## OS-IN-2018-004 Change of laser marking position for Kx CSLyM.zz

**Objective** Change of laser marking position

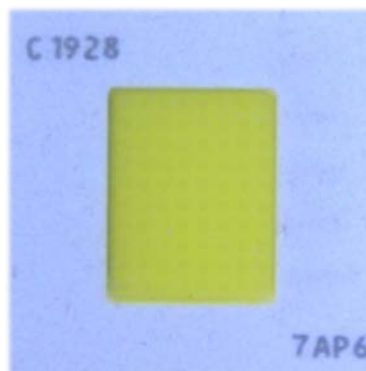
**Background** Harmonization of the laser mark position to improve visual inspection capability.

Current:

New:
